**Application by
Fingal County Council
for Waste Licence Application W0231-01
for Fingal Landfill, Co. Dublin**

***Replies to Request
for further information in accordance with
Article 14(2)(b)(ii) of the Waste
Management Regulations***

December 2006

Figure 5.1

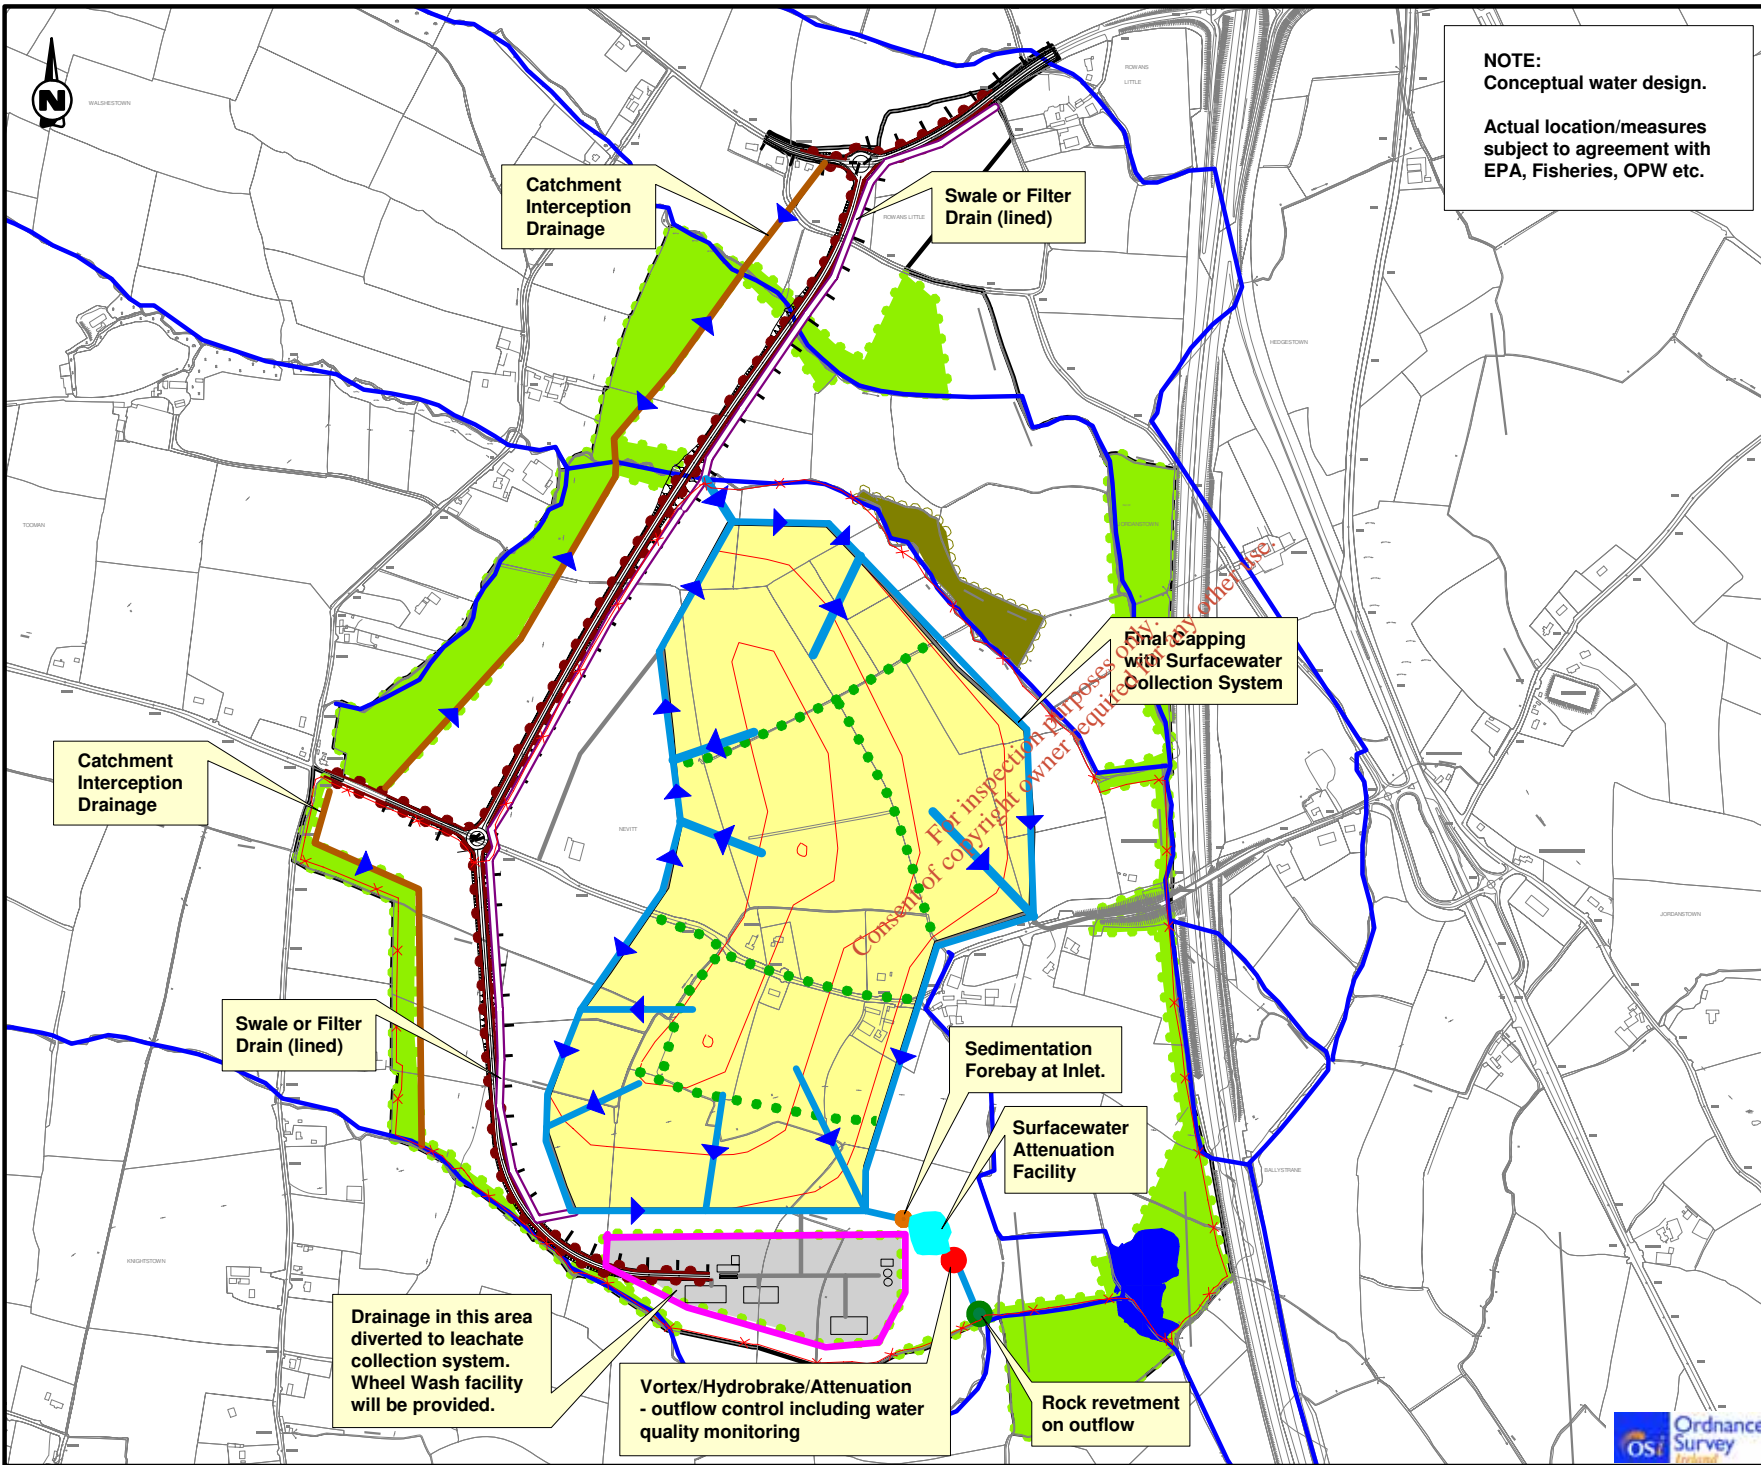
Provide a schematic of the proposed surface water collection and management system including details of abatement such as oil interceptors and hydro-breaks.

The proposed location of the surface water attenuation pond (see Figure B.2.1 of the licence application) is within the area indicated as being subject to flooding in Volume 3 of the EIS. Flooding of the attenuation system will prevent the system from operating effectively. Please provide an assessment detailing the most appropriate location for the attenuation pond.

A schematic of the SuDS layout is provided in **Figure 5.1** and specimen drawings of possible surface water collection and management systems are shown in **Figures 5.2 to 5.4**. The catchment interception drainage shall be designed to intercept and convey Greenfield runoff and discharge to the local streams. Road runoff drainage shall be conveyed using lined filter drains or swales and convey road runoff to the attenuation facility prior to discharge. The attenuation facility shall utilise a vortex type flow control as well as rock revetment at the outlet for additional velocity /erosion control. In addition, a sedimentation forebay is to be provided for sediment control with access for maintenance. A bypass mechanism and consideration of overland flow routes will be provided to facilitate the safe passage of water in excess of the 100-year event.

The location of the pond should be positioned to allow the conveyance of surface water flow by gravity and should be integrated, where possible with the landscape. An indicative location is provided in **Figure 5.1**.

Figure **3.6.1**

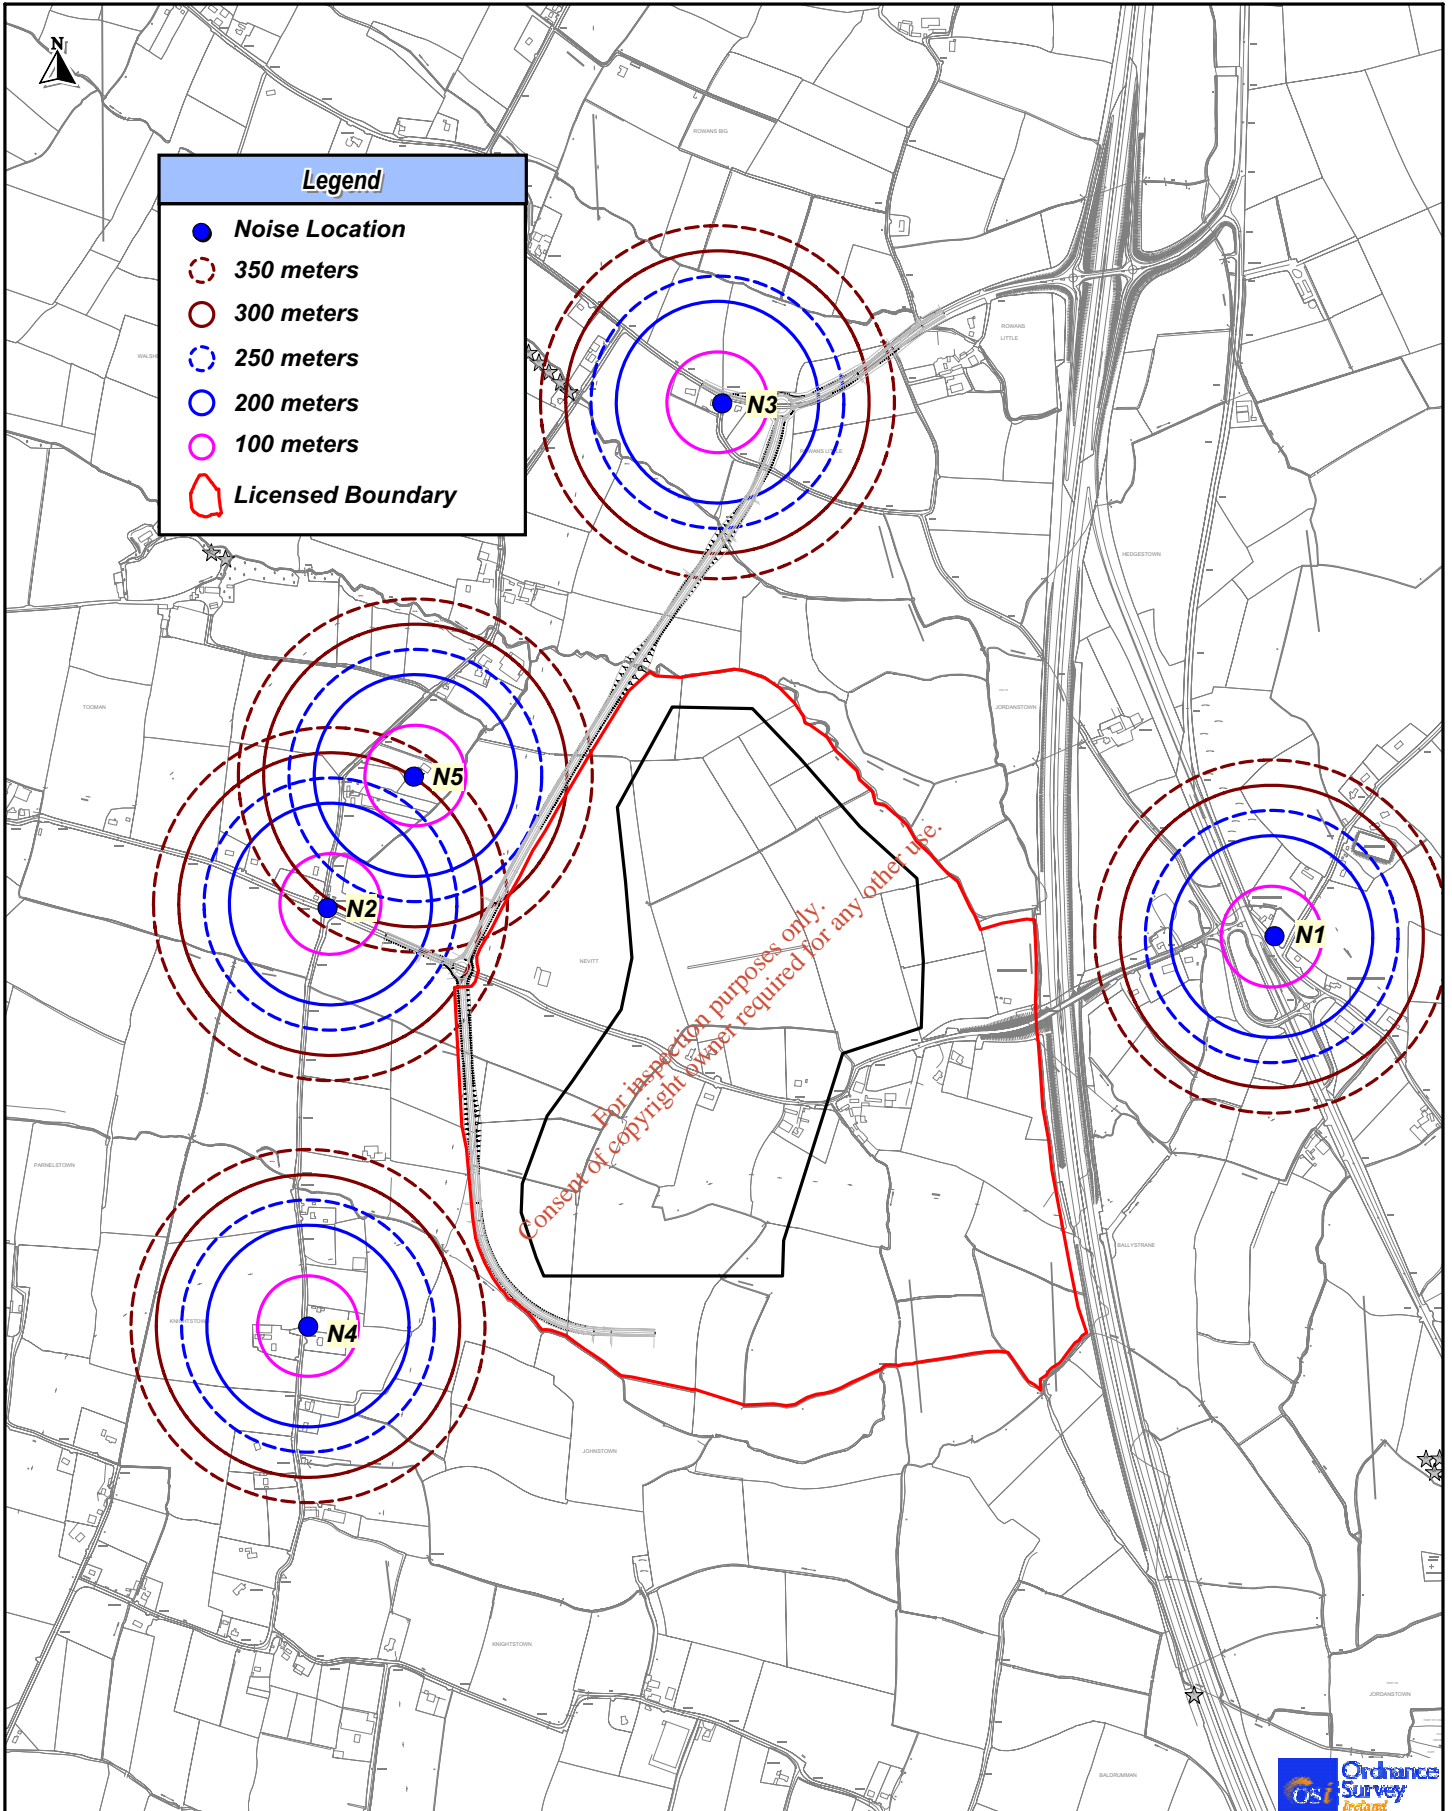
With regard to the proposed noise monitoring locations, provide a copy of Figure 3.6.1 which includes the proposed licence boundary as well as the landfill footprint.

Revised copy of Figure 3.6.1 from Volume 2 of the EIS.

Figure **20.1**

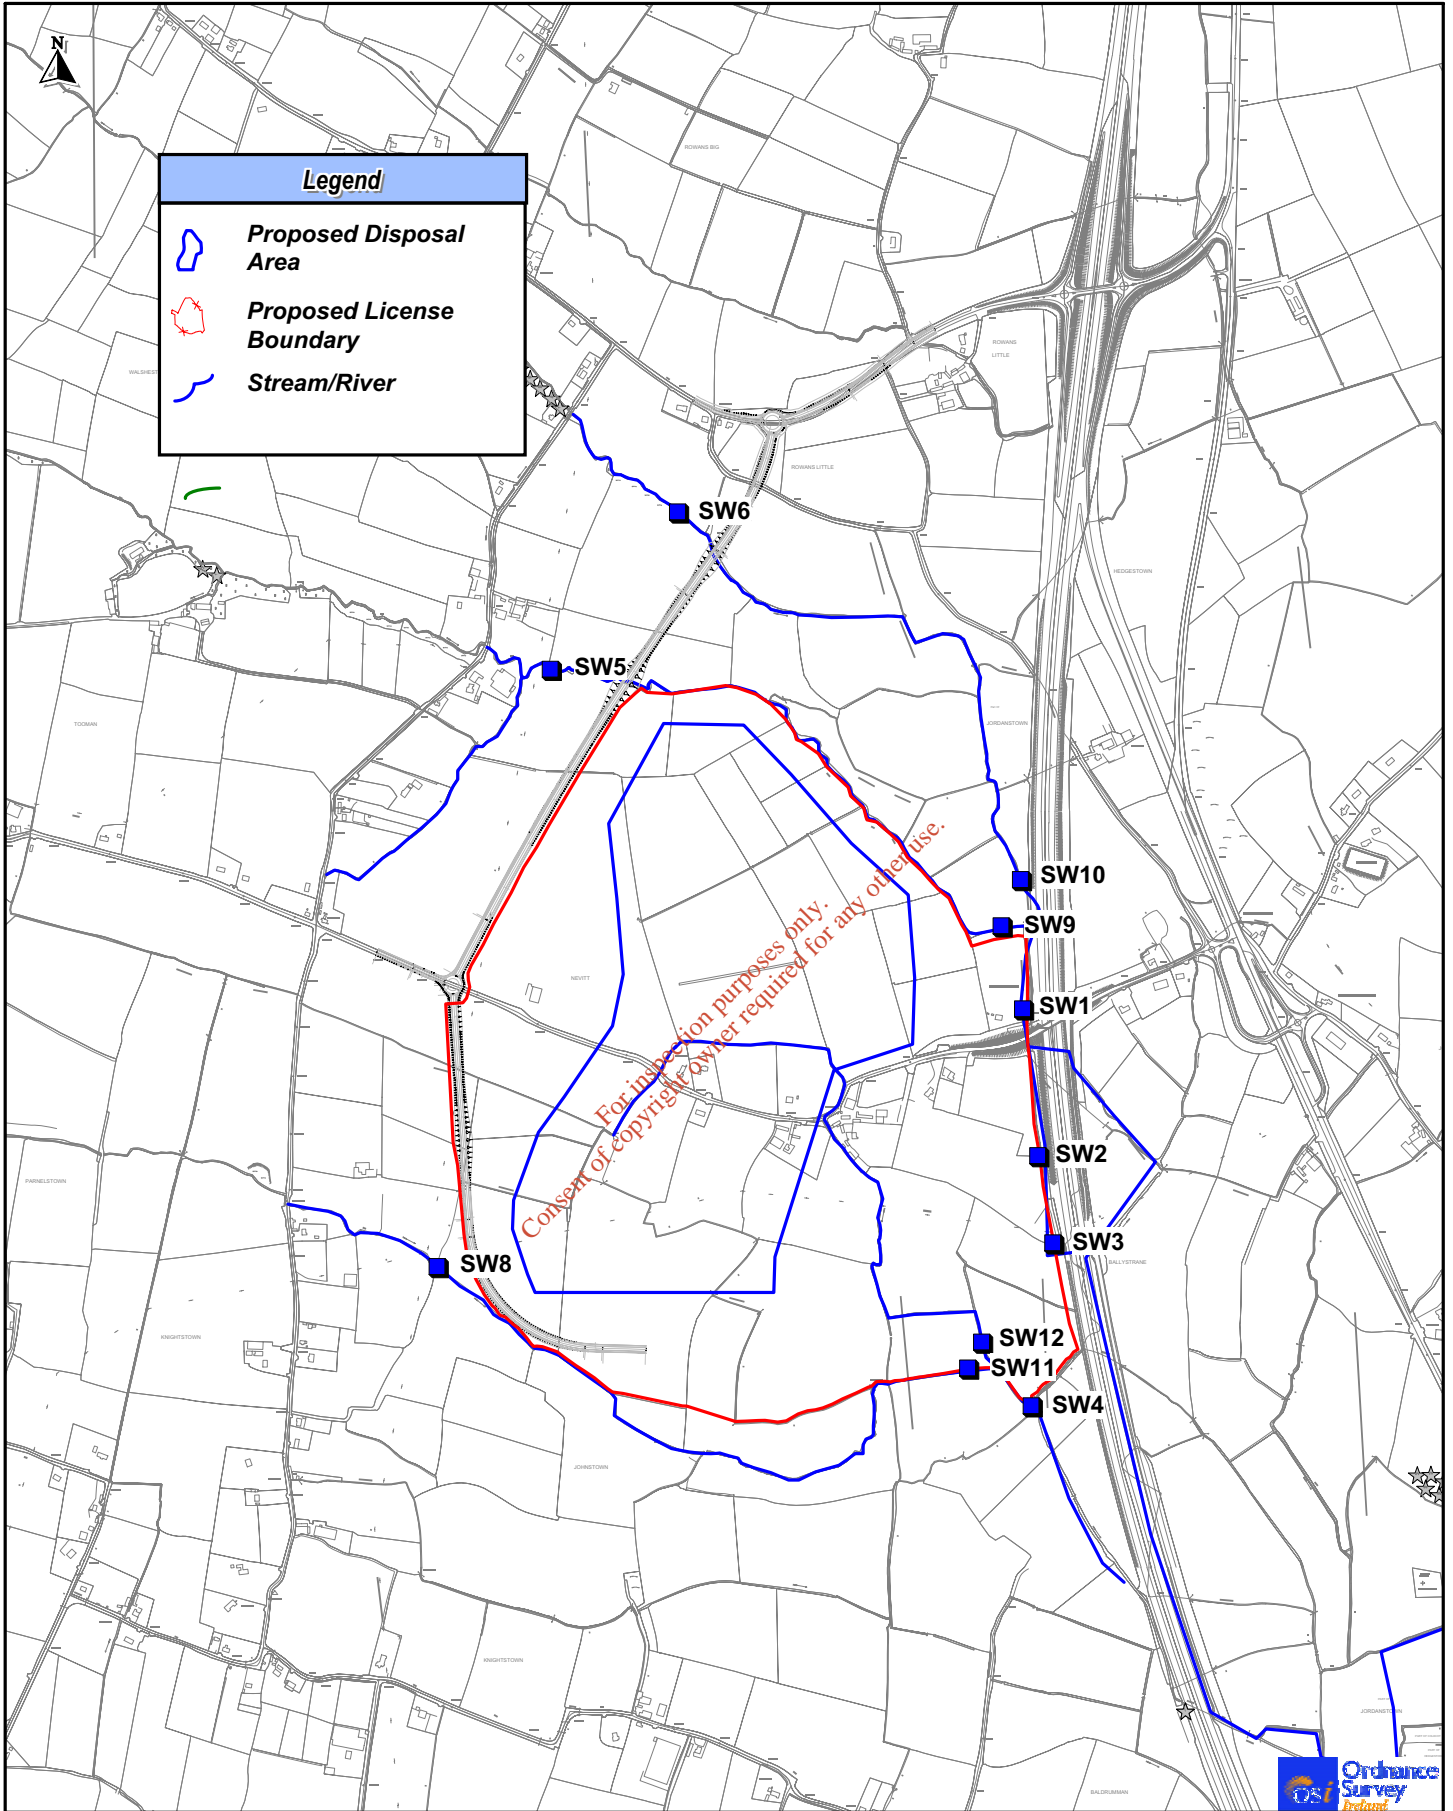
Table 2.4 of the main EIS report indicates that a sediment assessment has been completed, however no information on sediment quality is presented in Section 3.8 of the main EIS report. Provide details of any further proposed pre-operational baseline monitoring of surface water quality in line with the requirements of the most recent EPA Landfill Monitoring Manual (Appendix C).

Pre-operational baseline monitoring of surface water quality will be undertaken at the eleven locations shown in **Figure 20.1** on a quarterly basis for one year prior to construction as per the requirements of the *EPA Landfill Monitoring Manual (Appendix C)*. The range of parameters to be assessed will be in accordance with Table C.2 of *EPA Landfill Monitoring Manual*. Seven of these locations are the same water quality sites used for the EIS with the same reference numbers.

Figure **21.2**

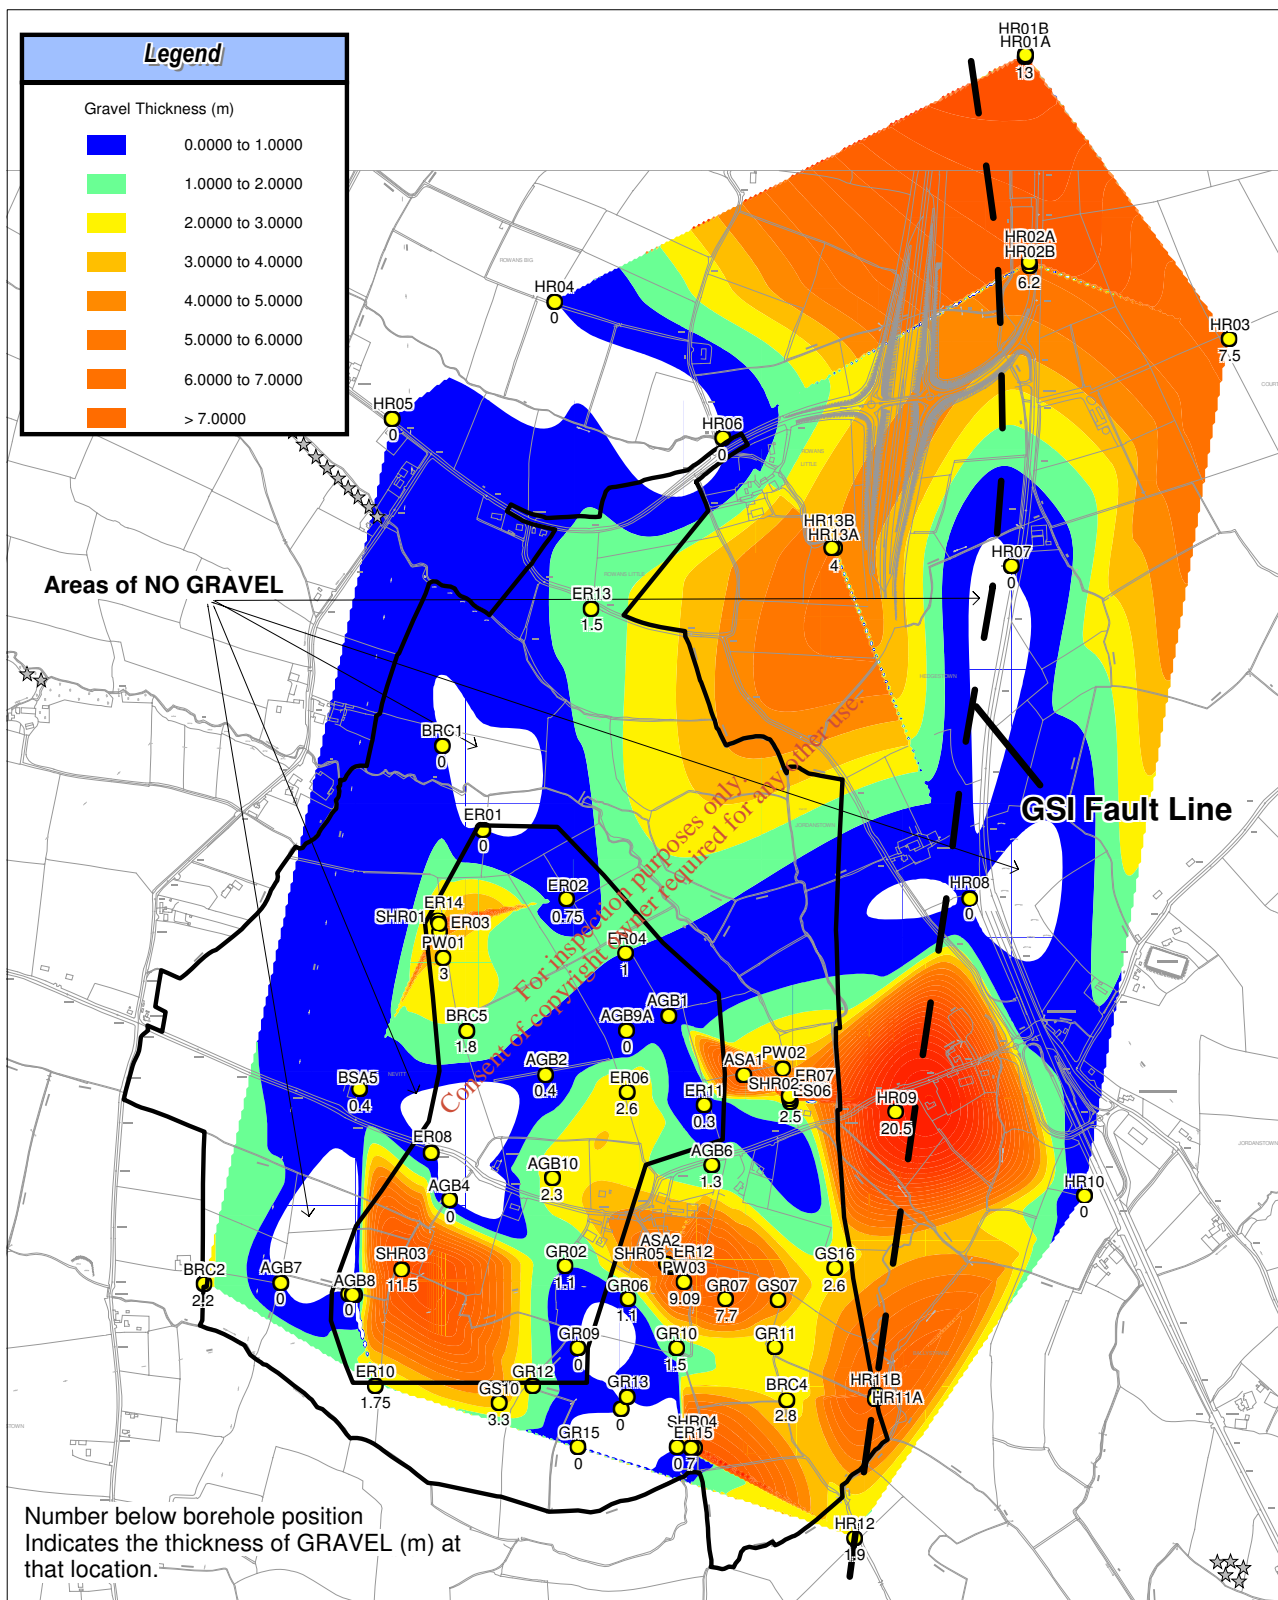
3. *Section 6.18 of the EIS Non-Technical Summary reports that sand/gravel deposits 'lie outside of the landfill footprint'. Table 4.2 of Appendix I (and also review of borehole logs) indicates the occurrence of gravel deposits in 14 of the boreholes within the landfill footprint. Clarify the statement made in Section 6.18 of the EIS NTS and detail the potential impact of these gravel deposits on the potential environmental impacts associated with the proposed operation of the landfill. Provide, in plan view, contour plots of the extent and thickness of sub-clay gravels. Provide an assessment of the importance of the gravel as an aquifer.*

- 3) There are no sand/gravel deposits *directly underlying* the landfill footprint. Any sand and gravel deposits encountered beneath the landfill footprint underlie a substantial thickness (at least 10m) of low permeability clay deposits. The significance of these deposits is that they result in a low vulnerability to pollution of groundwater in the underlying sand and gravel deposits and the bedrock aquifer beneath that.

A contour map showing the extent and thickness of gravel deposits *which underlie a minimum 10m thickness of low permeability clay*¹ is given on **Figure 21.2**. The plot indicates that the thickness of deposits varies from being absent to over 17m within the study area. Beneath the landfill footprint itself, the maximum gravel thickness encountered is 11.5m. The contour plot also illustrates the discontinuous nature of the gravel deposits, i.e. there are areas where the gravels do not occur. The GSI have criteria for the classification of gravel deposits as aquifers. For a gravel deposit to be classified as an aquifer it must have a high permeability and be a minimum 10m thickness over an area of at least 1km². This would classify it as being of local importance. To be classified as a Regionally Important aquifer, the deposit must fulfil these criteria but have an aerial extent of >10km². The contour map illustrates that significant thicknesses of gravel >10m over an areal extent of at least 1km² do not occur beneath the landfill footprint. Therefore the sand and gravel deposits underlying the thick clays beneath the landfill footprint cannot be classified as an aquifer in their own right.

The hydrogeological significance of the gravel deposits is that, where they occur, they are in hydraulic connectivity with the underlying bedrock and thus provide additional storage to the bedrock aquifer. However, the predominant hydrogeological pathway is within the bedrock aquifer itself.
